## Service Bulletin Car Stereo

Model: XM-2040 No. **426**

Subject: THE CAR BATTERY MAY GO DEAD Date: May 6, 1997

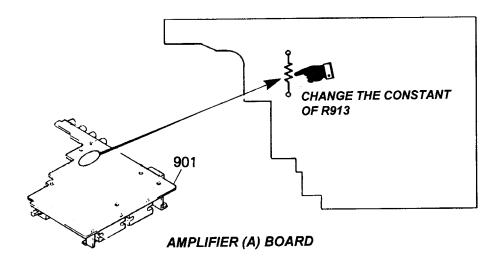
(111) The Car battery may go dead with audio systems using the XM-2040.

**Solution:** The value of R913 is incorrect. Change R913 to the new part listed in the table

below. The resistor is on Amplifier (A) Board.

REF	FORMER		NEW	
	DESCRIPTION	PART NUMBER	DESCRIPTION	PART NUMBER
R913	1K OHM RESISTOR	1-249-417-11	22K OHM RESISTOR	1-249-433-11
